SUPPLEMENTAL AIRPLANE MAINTENANCE MANUAL

Flap Actuator with Changed Motor

Doc. No. : 6.02.15 - DEO 40-015

Design Change Advisory : DEO 40-015

Title	Drawing Number	Revision Number	Number of Sheets
Schematic, Flaps Wiring	E44-9227-50-01_01	-	1

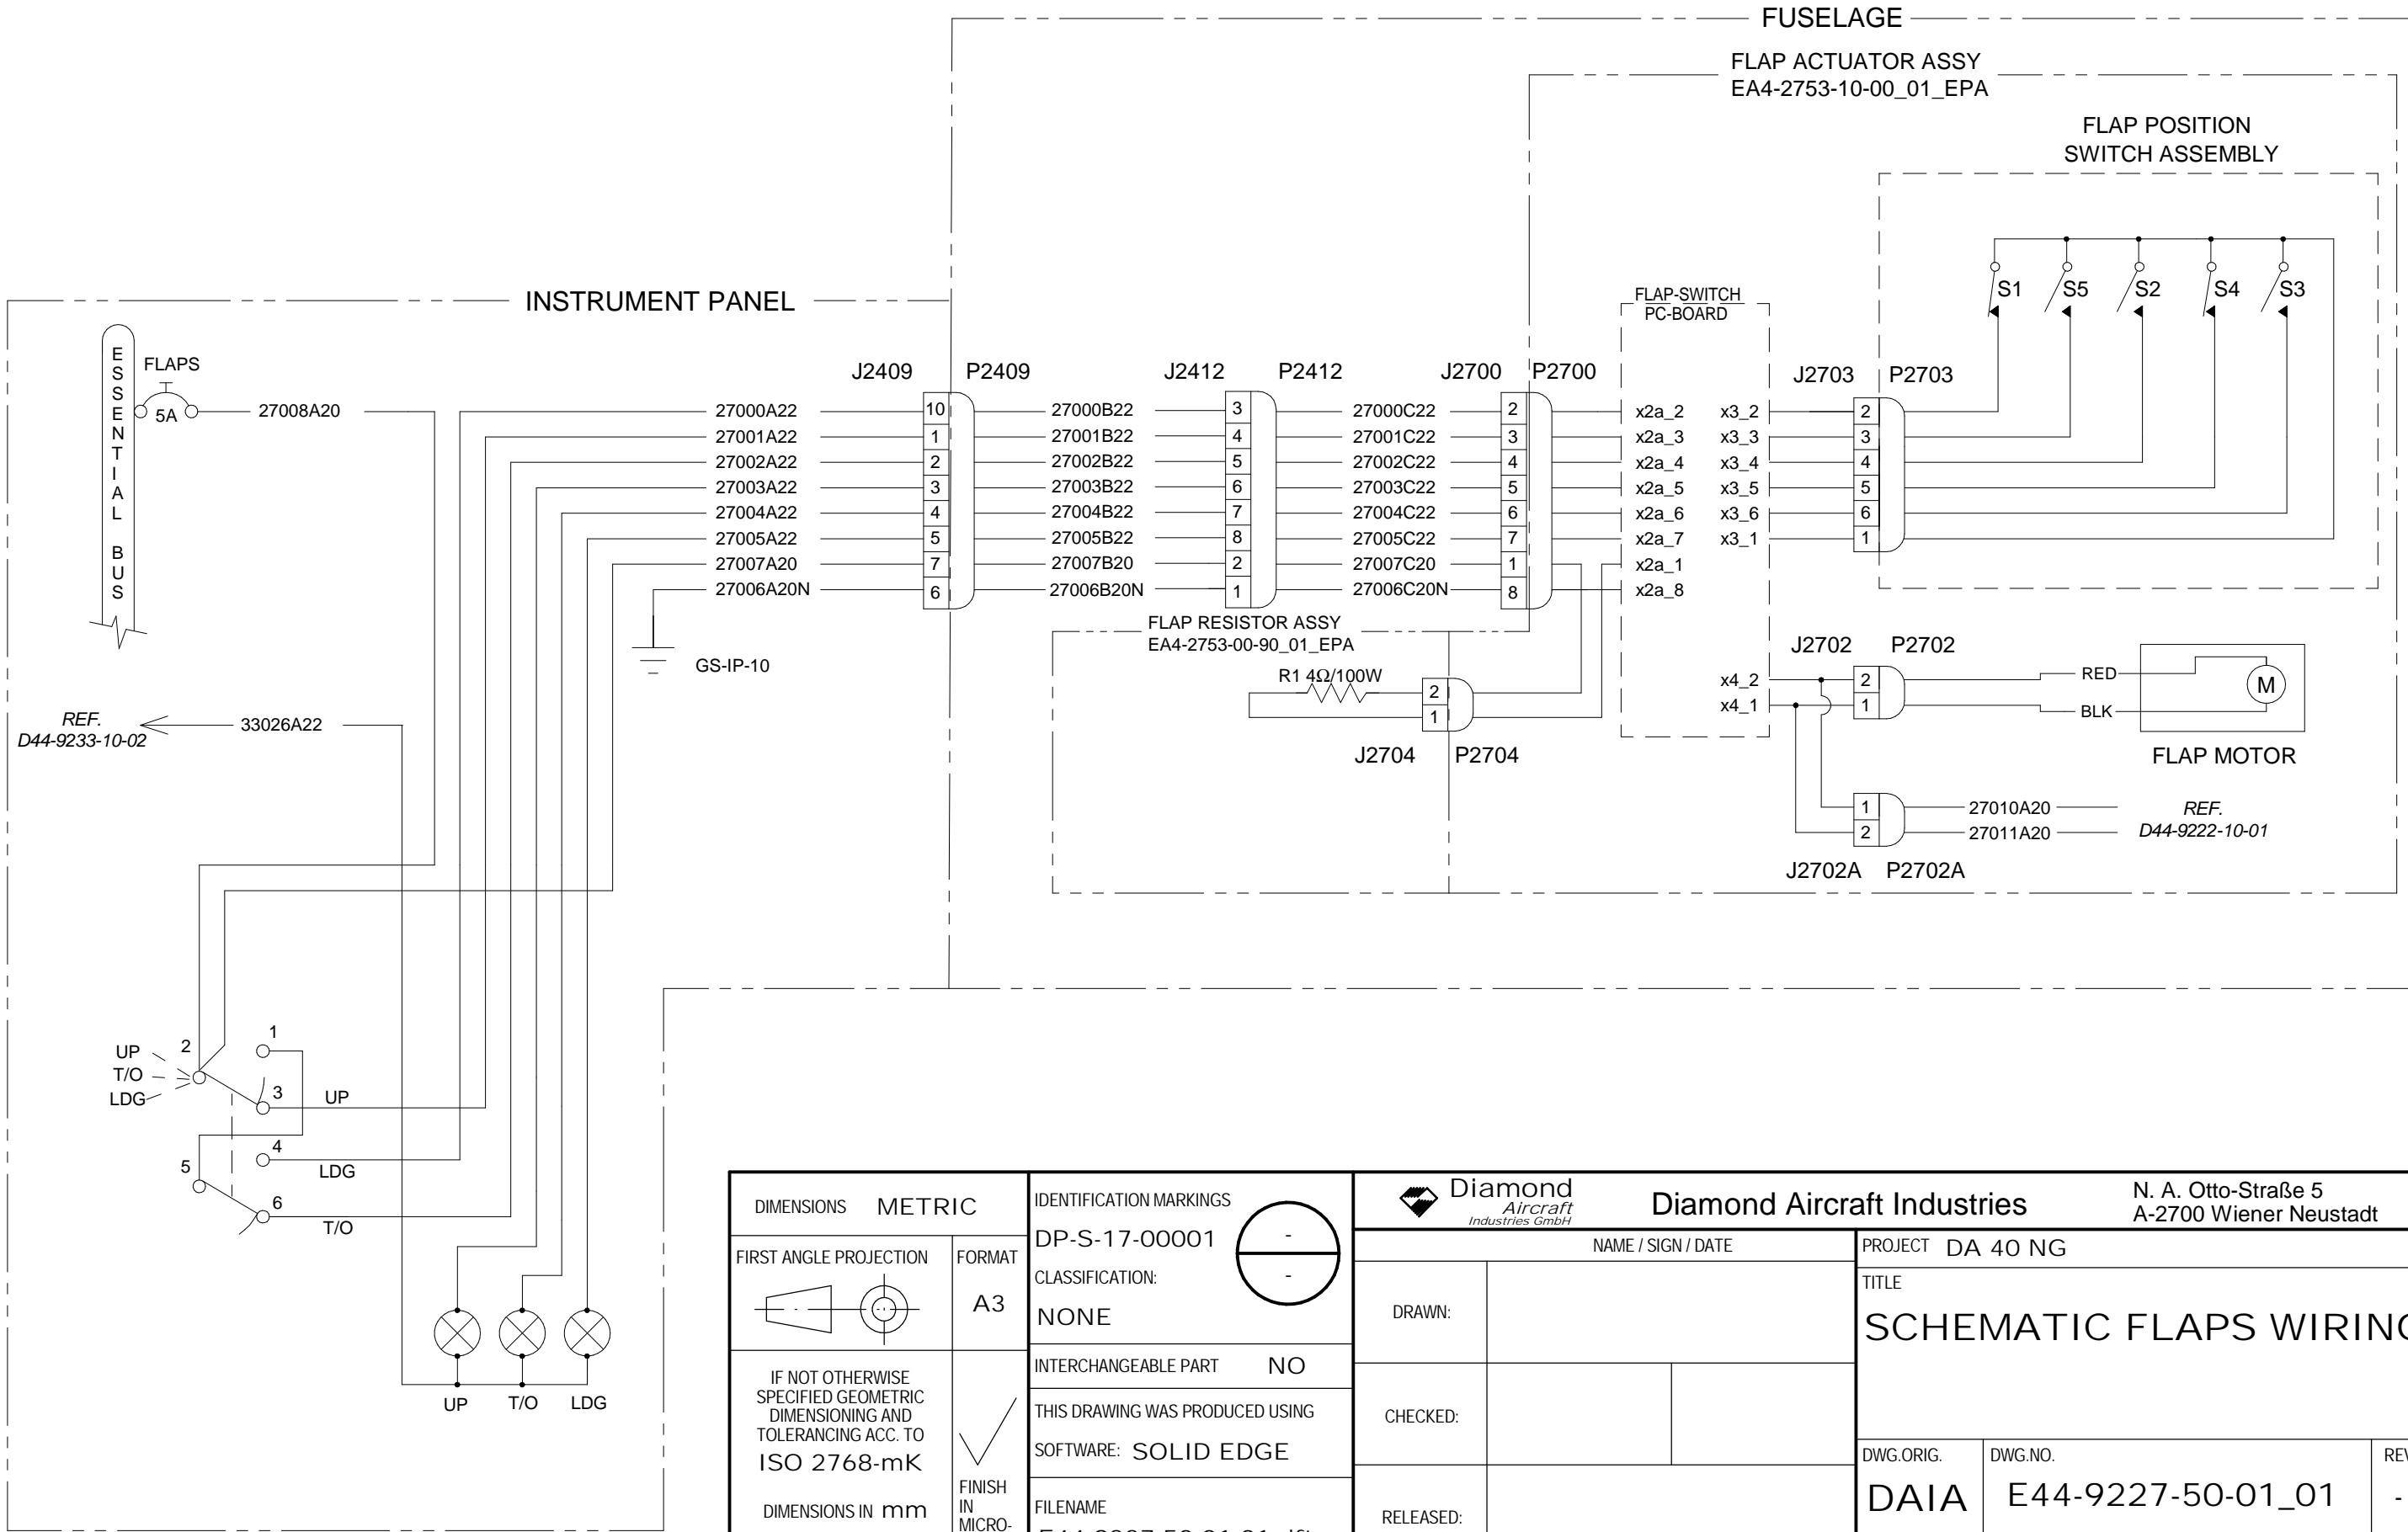
A new flap actuator is replacing the previous model for obsolescence reasons. The new flap actuator (EA4-2753-10-00_01_EPA) requires a new flap resistor assembly (EA4-2753-00-90_01_EPA) and a new mounting bracket (EA4-2750-00-01_EPA) to install the flap actuator to the fuselage.
